**RESPONSES TO USEPA AND OEPA COMMENTS - OPERABLE UNIT 2
DRAFT FEASIBILITY STUDY - VOLUME 1 - NOVEMBER 1994 -
DRAFT**

**FERNALD ENVIRONMENTAL
MANAGEMENT PROJECT**

**RESPONSE TO USEPA AND
OHIO EPA COMMENTS
OU2 DRAFT
FEASIBILITY STUDY REPORT**

November 1994

FIGURE 1-15
GEOLOGIC CROSS SECTIONS
SOLID WASTE LANDFILL

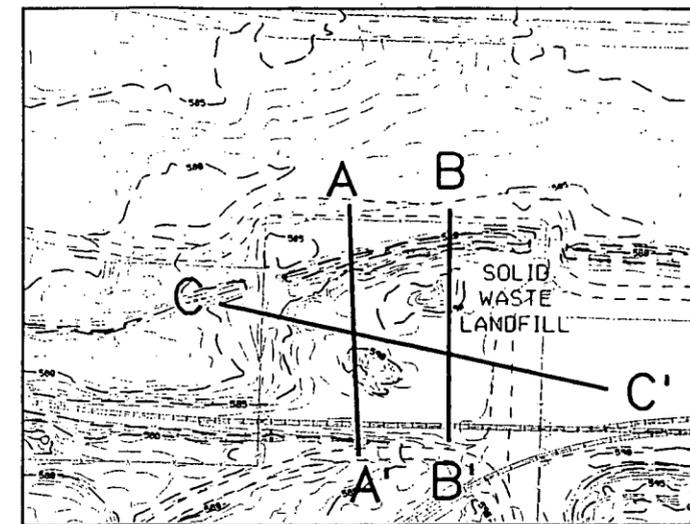
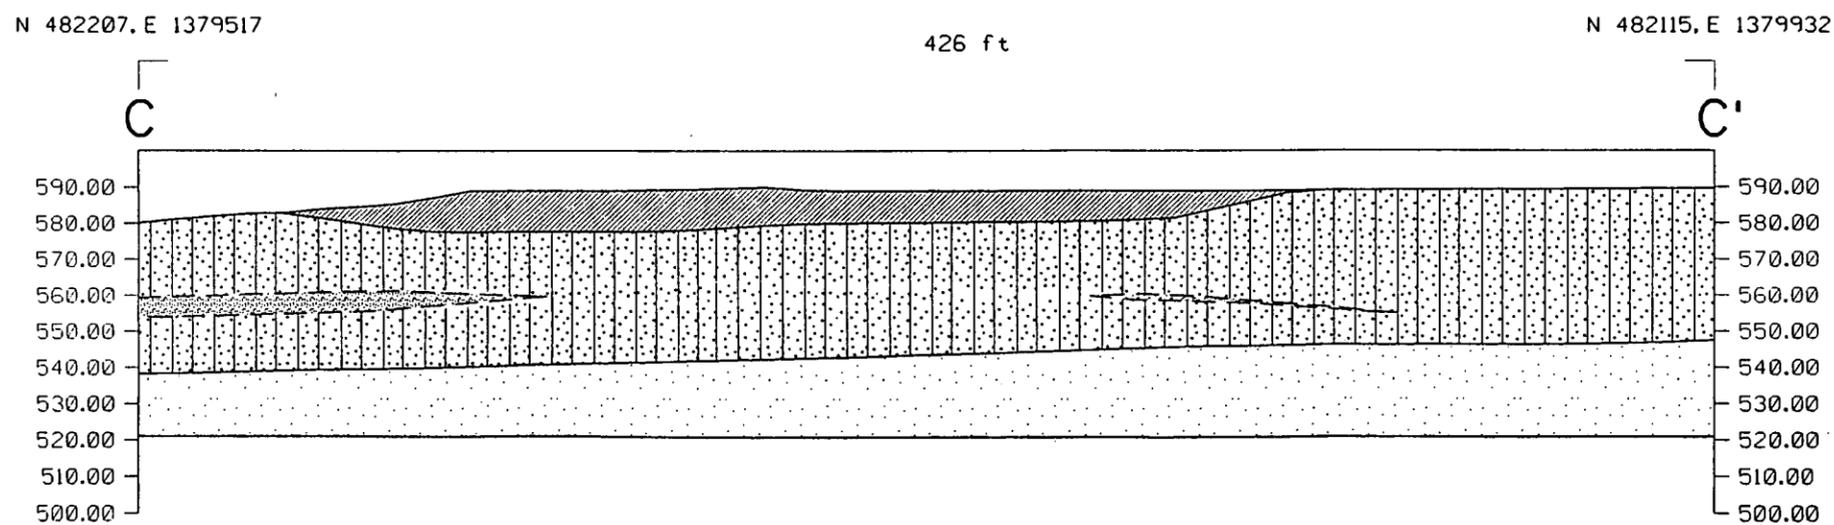
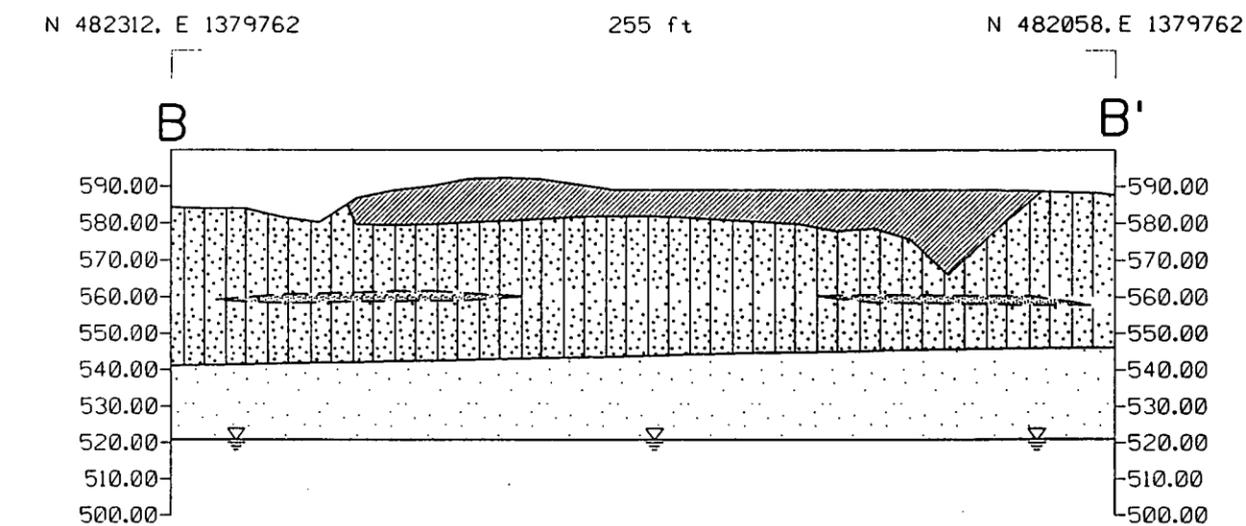
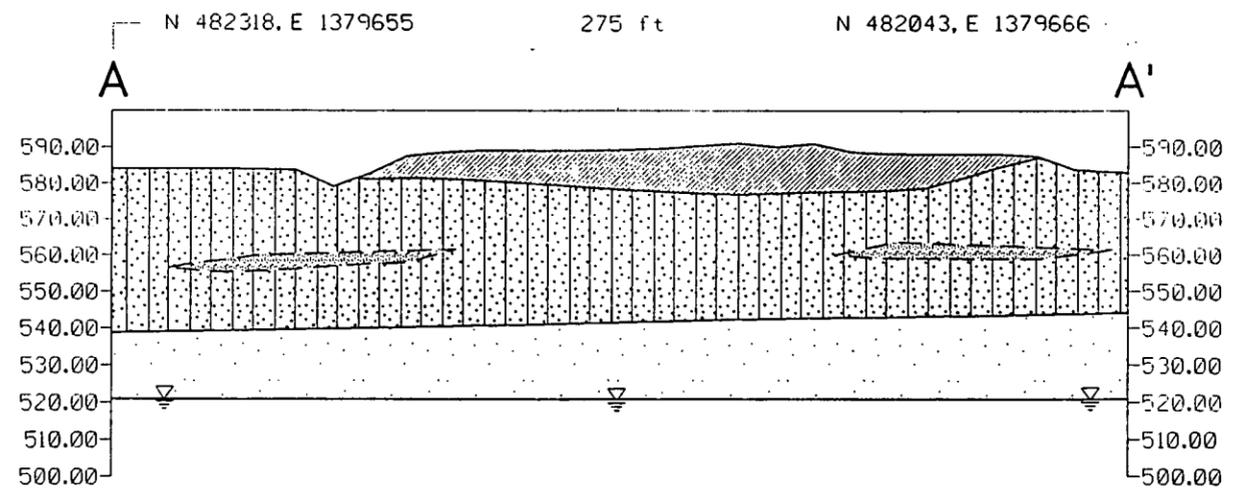
Commenting Organization: Ohio EPA Commentor: OFFO
Section #: Figure 1-17 Page #: 1-53 Line #: Code: C
Original Comment #: 10
Comment: Figure 1-15 has not been corrected. Please include the sand and gravel layer in the legend.
Response: Agreed. The legend symbol for sand and gravel does not agree with the figure. Figure 1-15 will be corrected by showing the proper symbol in the legend.
Action: Figure 1-15 was revised to indicate correct legend symbol for sand and gravel.

FIGURE 5-20
SITE PLAN
ALTERNATIVE 6
EXCAVATION AND ON-SITE AND
OFF-SITE DISPOSAL
INACTIVE FLYASH PILE, SOUTH FIELD,
AND ACTIVE FLYASH PILE

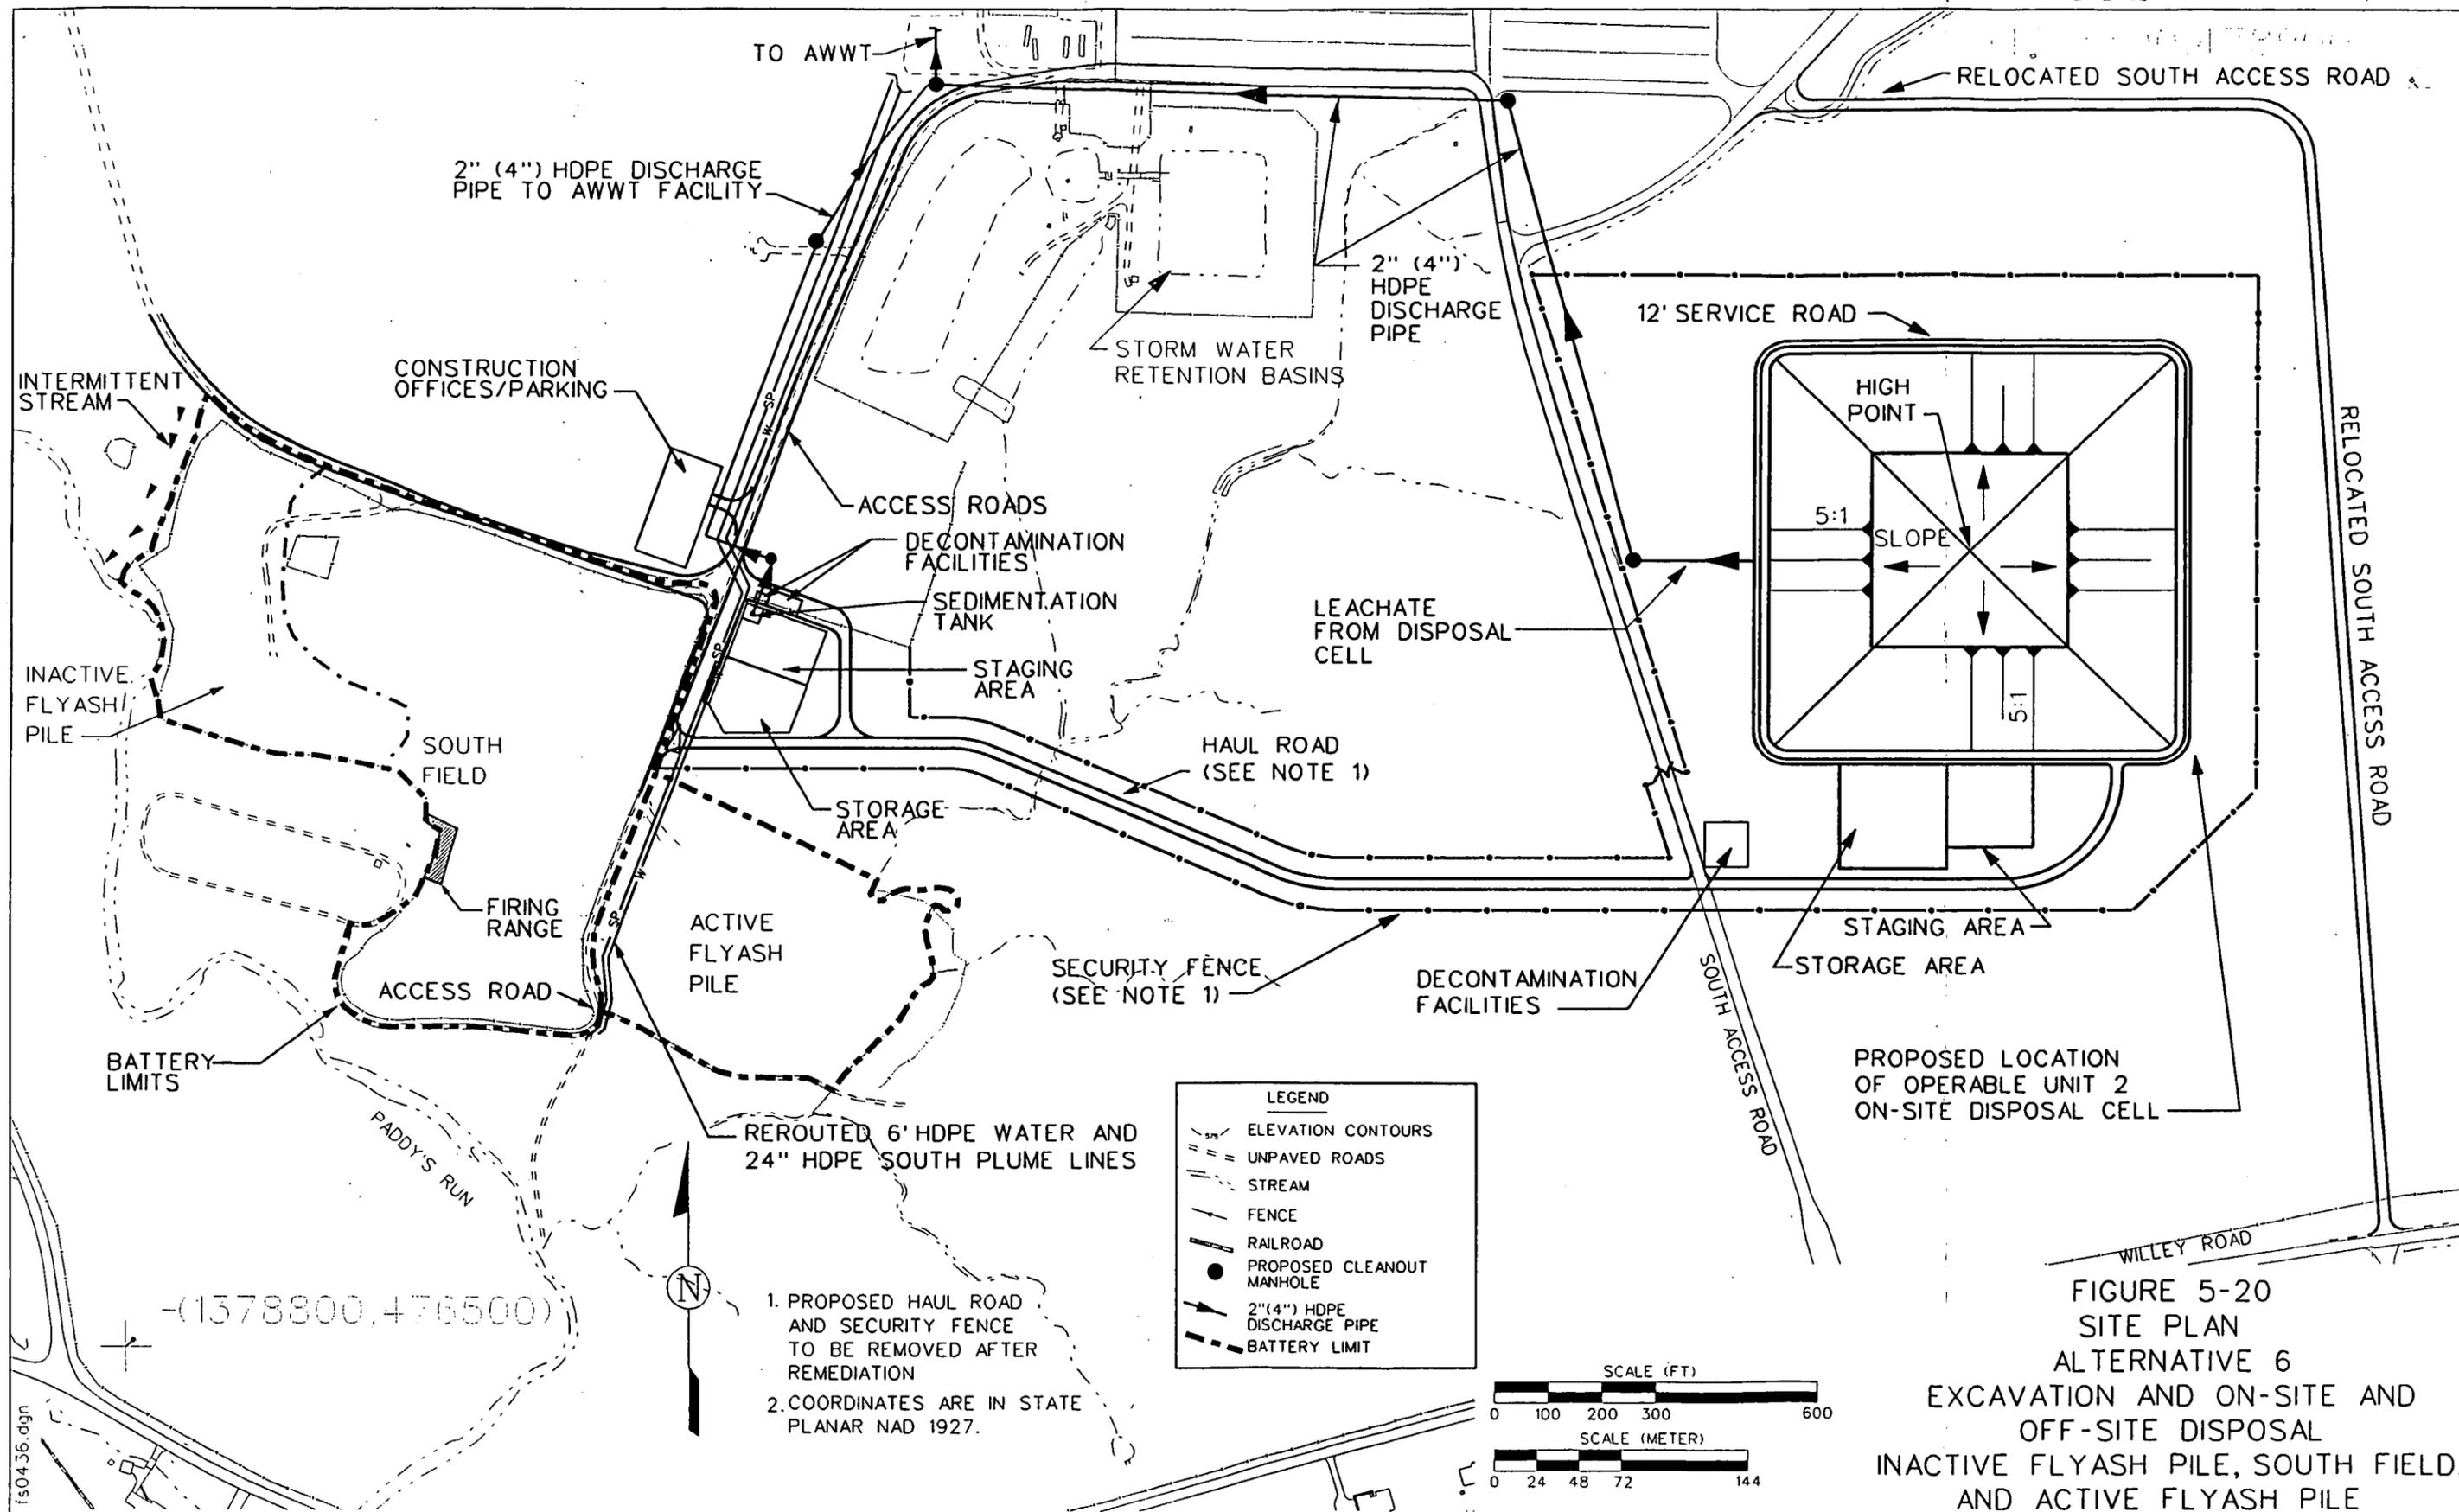
Comment: Ohio EPA has expressed concerns during previous meetings regarding infiltration through the side slopes where the composite cap does not extend. DOE should revise the design to extend the cap over these berms. In order to comply with Ohio EPA solid waste disposal facility design requirements the synthetic liner and cap should meet at the edges of the cell.

Page 5-90, Figure 5-20 and Page 5-98, Figure 5-22: Corrected size of the proposed on-site disposal cell based on revised cap design and cell cross-sections.
